# Bulletin Number - BP4C KVC - 02

<b>Project</b>	Steamboat Base Village Redevelopment	<b>Date</b>	12/13/2021
<b>Project Location</b>	Steamboat, Colorado	<b>Architect's Project Number</b>	03.7835.000
<b>Owner/Client</b>	Alterra Mountain Company / East West Partners	<b>File</b>	6BL <b>This is page</b> 1 of 2
<b>To</b>	Saunders Construction Inc.	<b>Attention</b>	Bryan Sculthorpe
<b>Address</b>	86 Inverness Place North		
<b>City</b>	Englewood	<b>State</b>	CO <b>Zip Code</b> 80112
<b>Delivered via:</b>	<input type="checkbox"/> <b>Messenger</b> <input type="checkbox"/> <b>Hand carried</b> <input type="checkbox"/> <b>Facsimile</b> <input type="checkbox"/> <b>Express</b> <input type="checkbox"/> <b>Pick-up</b> <input type="checkbox"/> <b>E-mail Address</b> <input type="checkbox"/> <b>Mail</b> <input type="checkbox"/> <b>UPS</b> <input checked="" type="checkbox"/> <b>Website Address</b> BIM360

### Description of Changes

- Updated MEP and arch roof plan
- Updated steel reinforcing for roof (sketch)

**1C-E1.201**

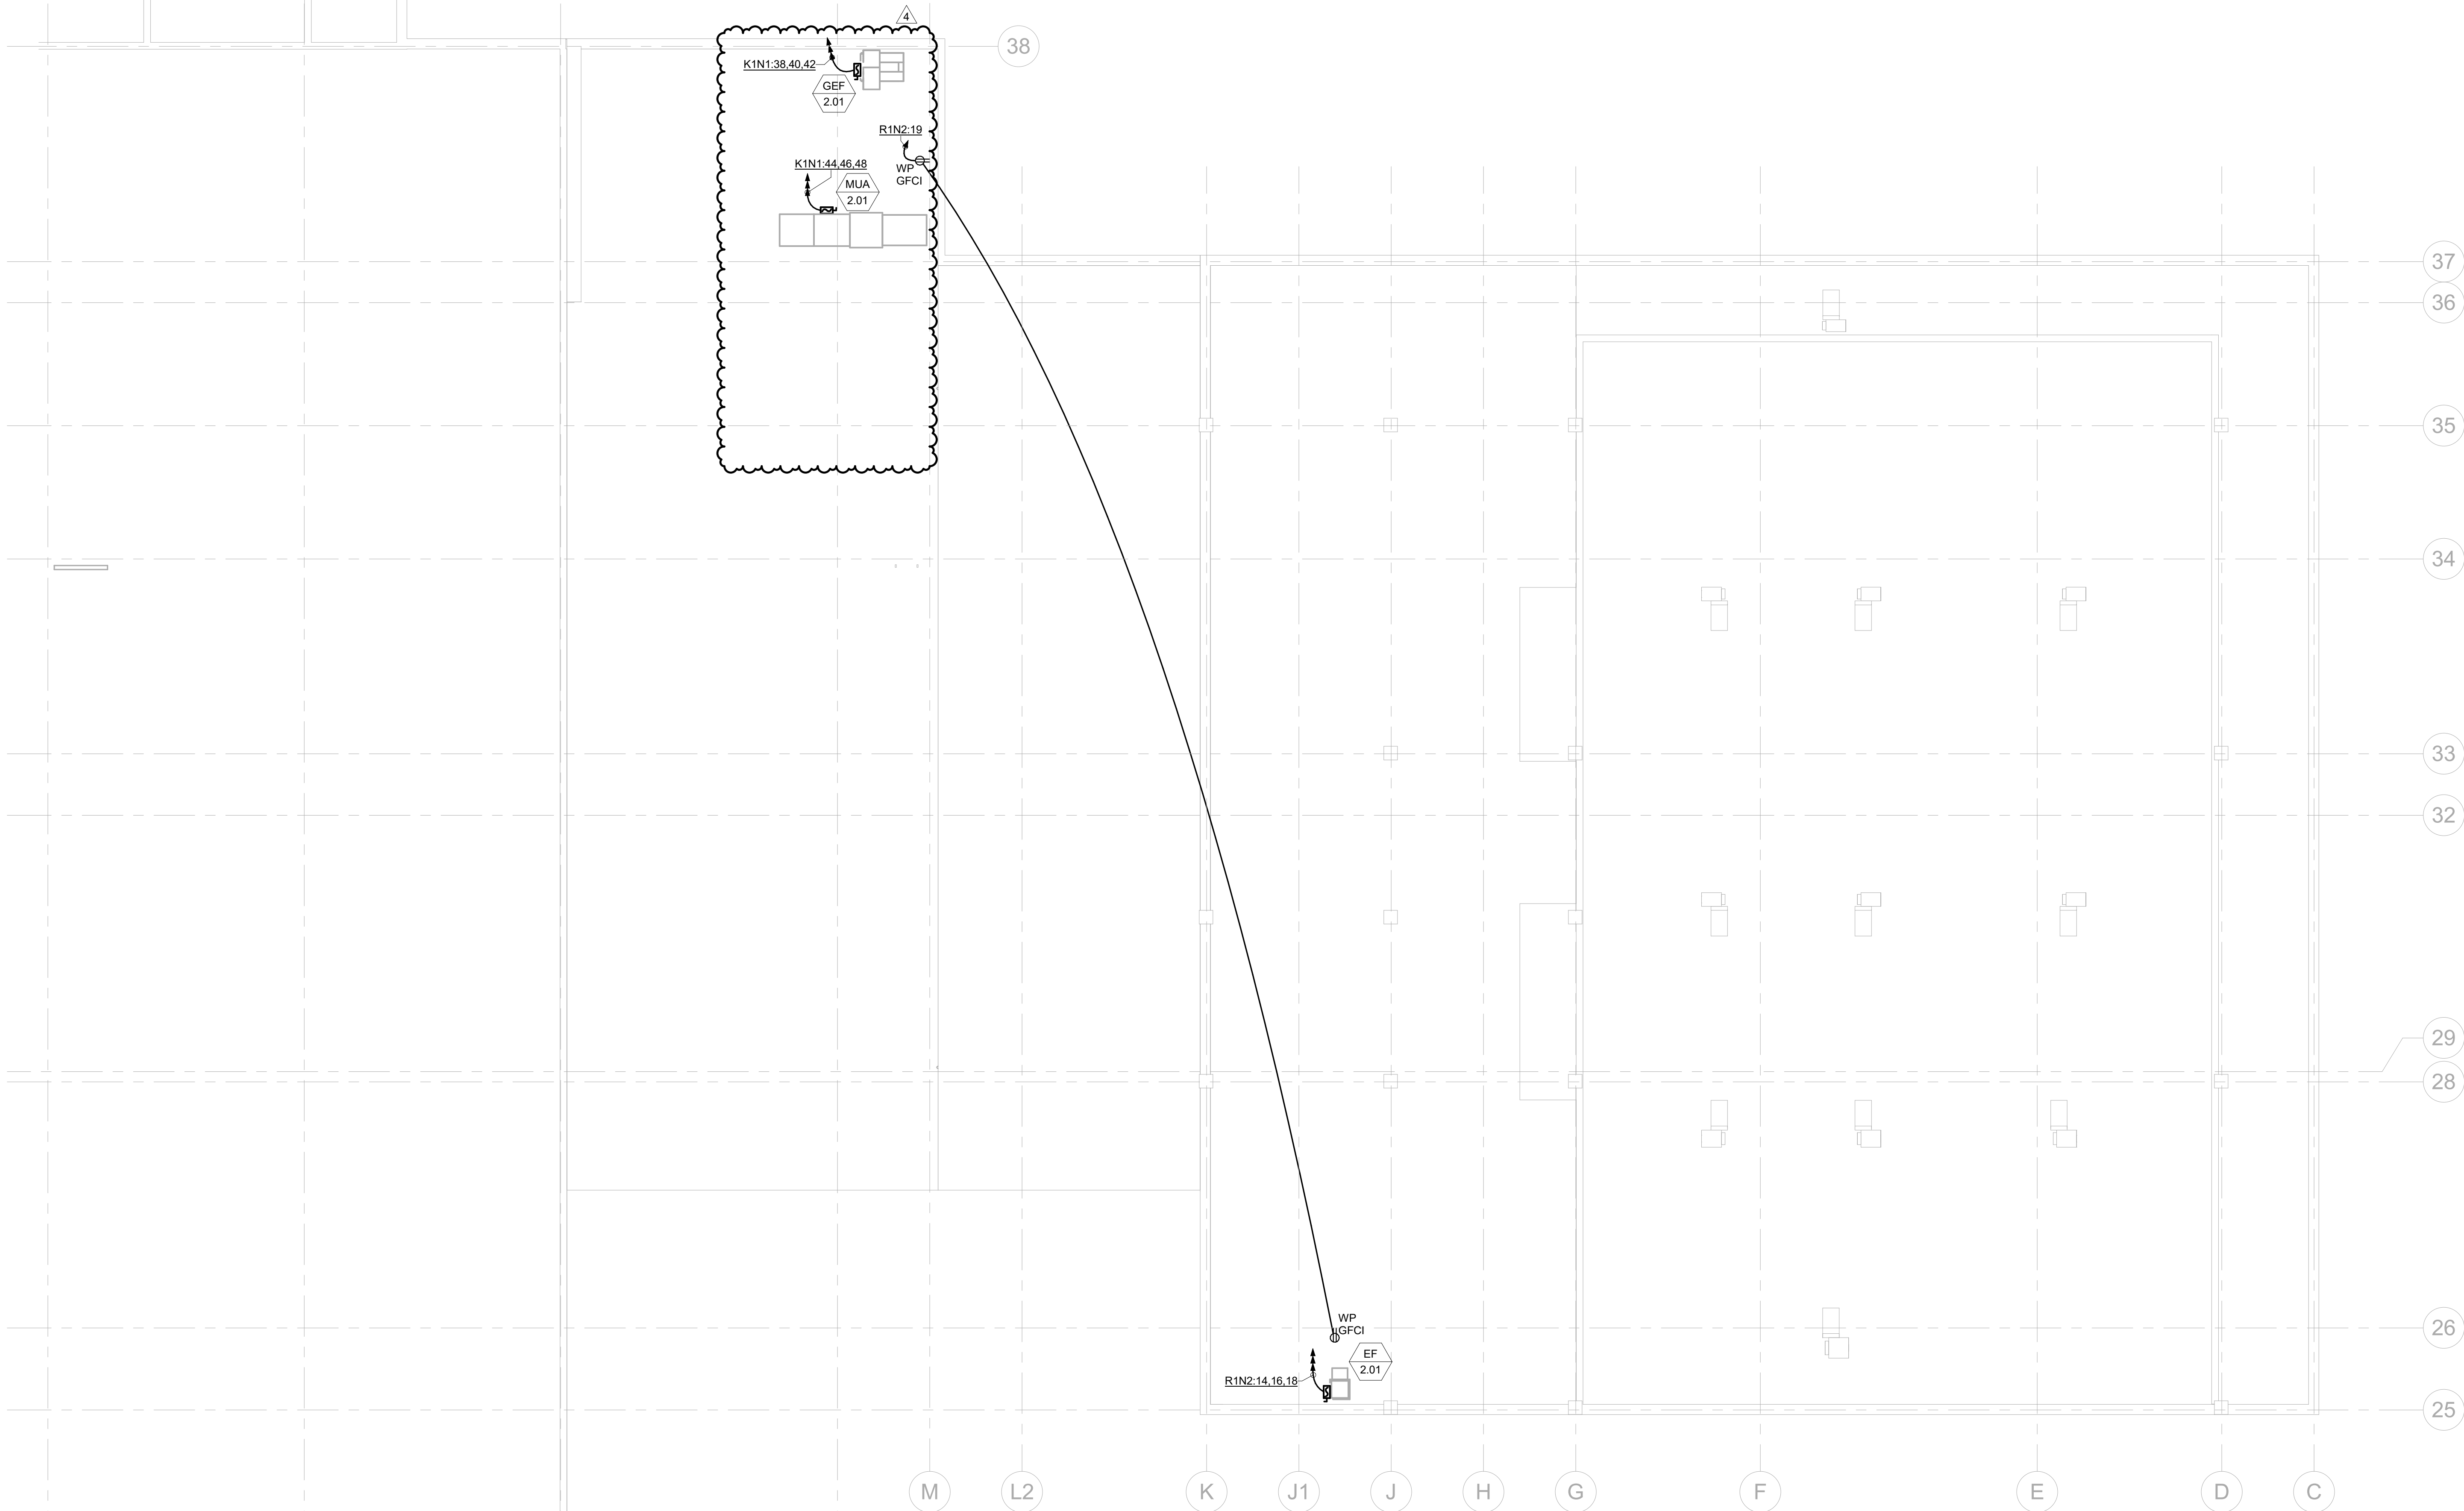
- 1C-E1.201
  - Relocated walk-in cooler condensing unit electrical connections to this level from roof level in previous issuance.
- 1C-E1.202
  - Relocated mechanical equipment connections to align with relocated mechanical equipment. Food Service Walk-In cooler condensing units were moved to level below.
